**YAMAHA MOTOR CORPORATION, U.S.A.**

97Y-230 (51)

## XVZ13LTJ/LTJC

## FACTORY MODIFICATION CAMPAIGN

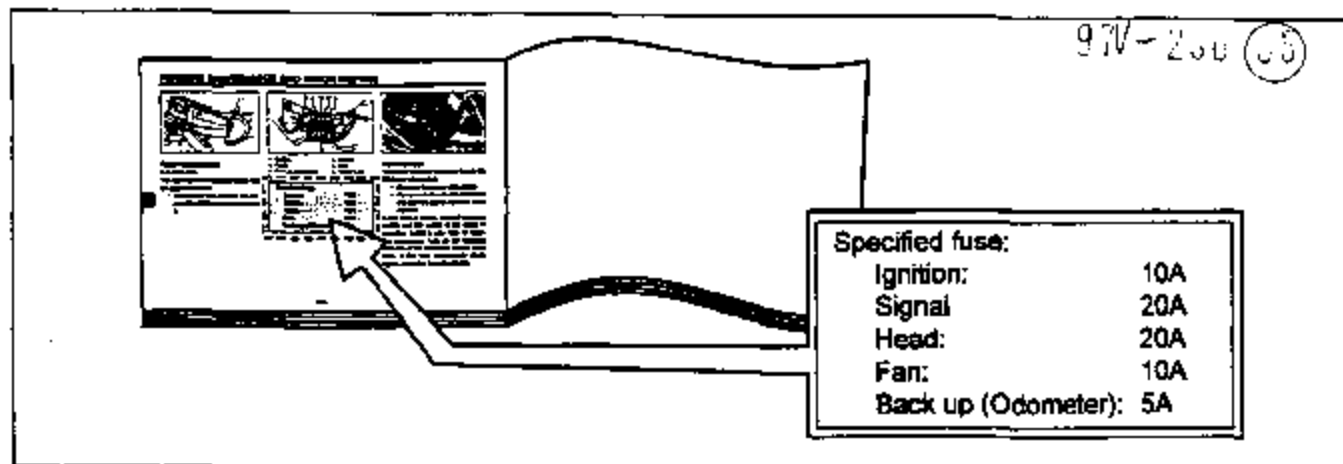
1. Please remove and discard the 10-amp signal fuse, the 15-amp headlight fuse and the 15 amp spare fuse. Replace these three fuses with the three 20-amp fuses in the kit.

**NOTE:** The headlight fuse is being replaced with a 20-amp fuse because the spare fuse holder is limited to three fuses. This will give the owner access to a replacement fuse of the proper type for either the brake/taillight or headlight circuit. The higher amp fuse does not compromise the headlight circuit in any way.

2. Place the corrected fuse box label in the fuse box lid.

#### IDENTIFICATION PROCEDURE

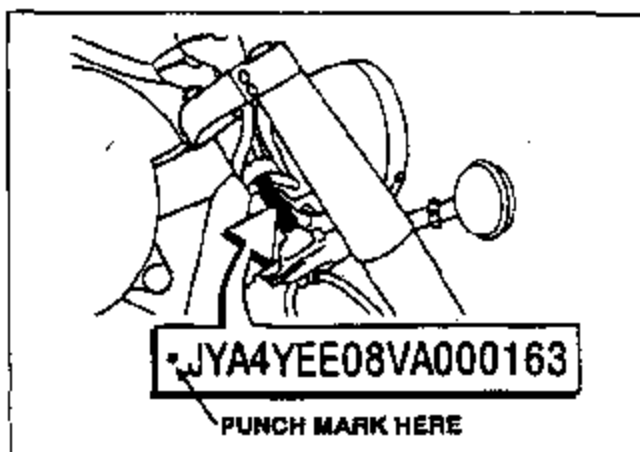
After modifying a unit, make a punch mark at the beginning of the frame number (VIN) on the steering head as shown in the illustration.
